Service Bulletin

Bulletin No.: 24-NA-055

Subject: Removable Sky Panel Creak Pop Snap Noise Hot Interior Temps

Brand:	Model:	Model Year:		VIN:		Engine:	Transmission:
		from	to	from	to		
GMC	Hummer EV Pickup	2023	2024				
	Hummer EV SUV	2024	2024

5832341

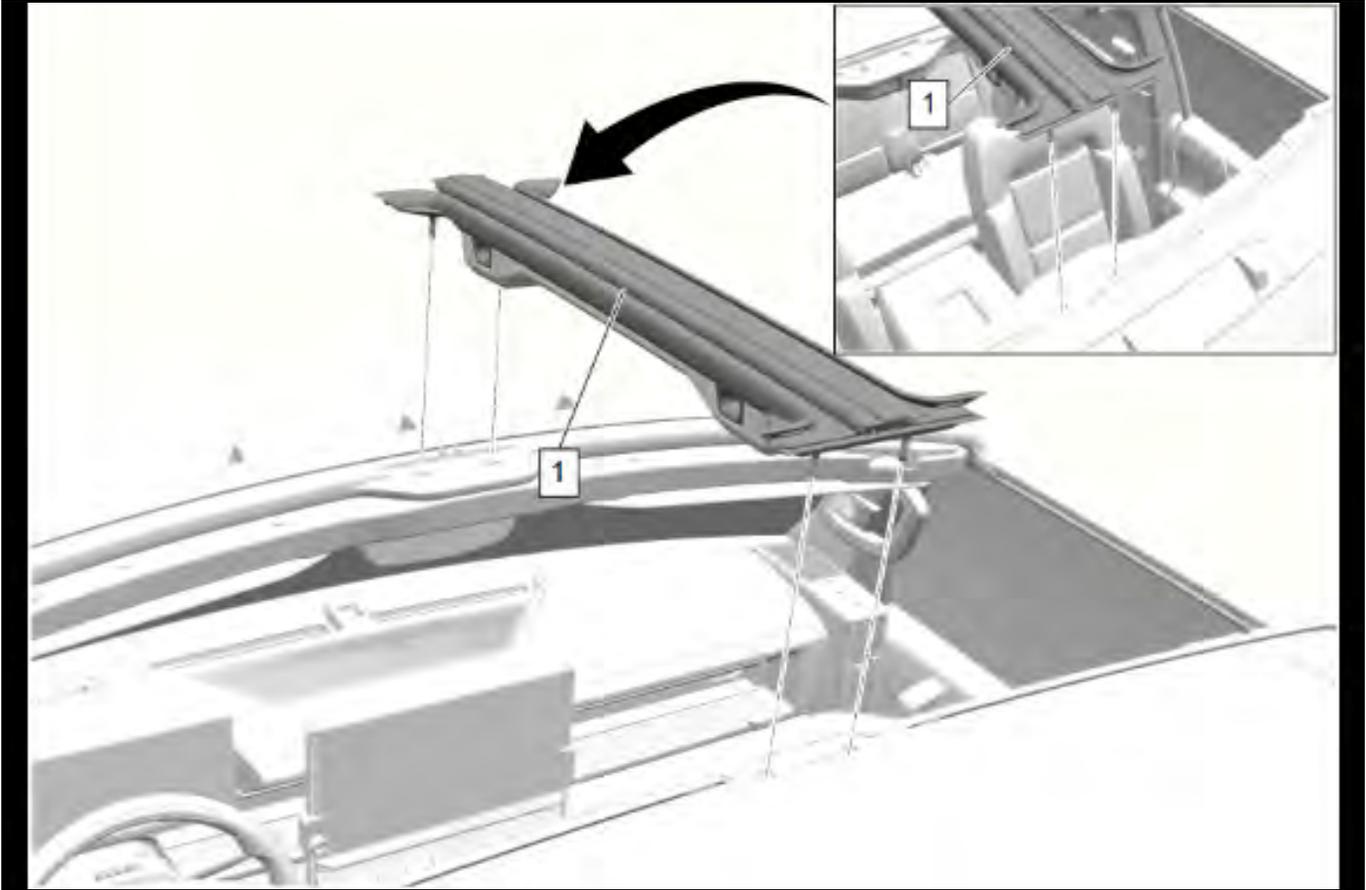
1. Remove the four nuts (1) from the Front I-Bar.

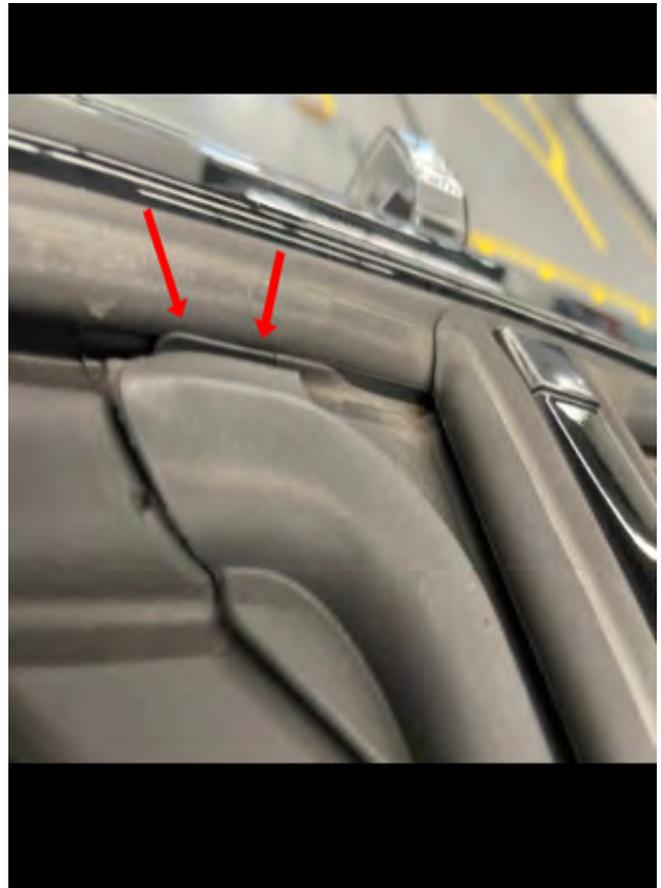
5. Unscrew the I-Bar pocket receivers from the I-bar.

6. Place a washer at each of the four bolt holes underneath the pocket receivers.
7. Reinstall the pocket receivers, torque to 9 nm.
8. Reattach the trim cover and push-pin fasteners.
Reinstall the front I-Bar in the correct orientation.

6430469

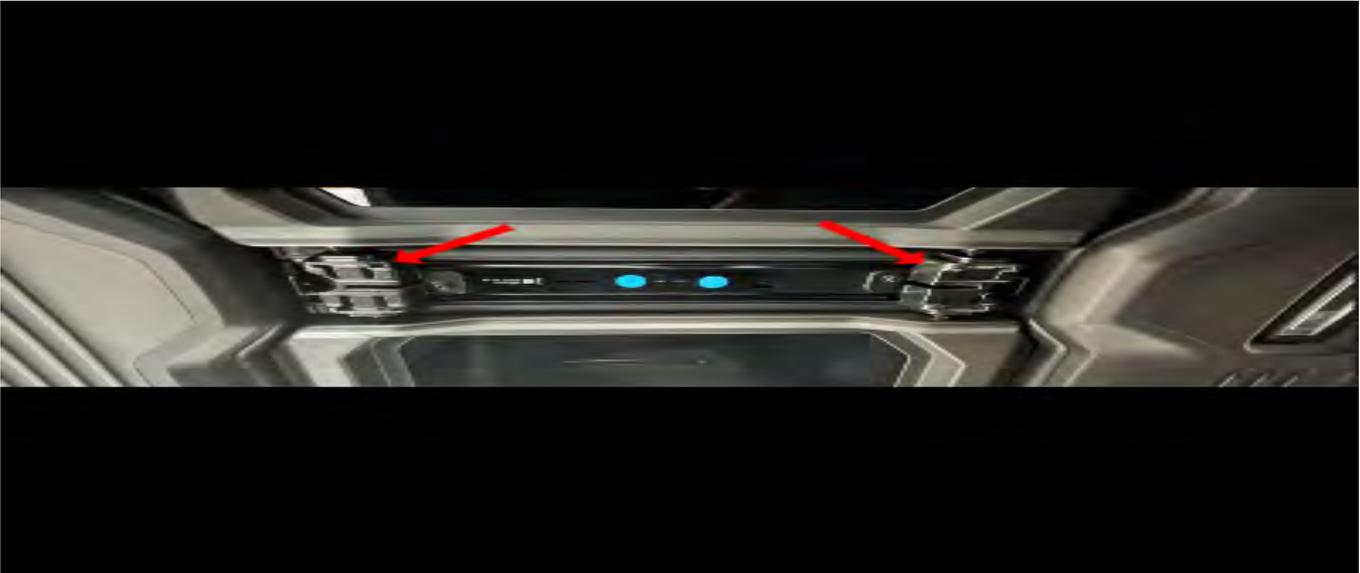
1. Remove the rear I-Bar trim panel by pulling down on the panel to disengage the retainers.

2. Remove both I-Bar pocket receivers.

3. Place a washer at each of the four bolt holes underneath the pocket receivers.
4. Reinstall the receivers to the I-Bar, torque to 9nm.
5. Reattach the rear I-Bar trim cover.
6. Use soapy water to clean the weather strips and then apply a very light application of AC Delco Super Lube to the weather strips.
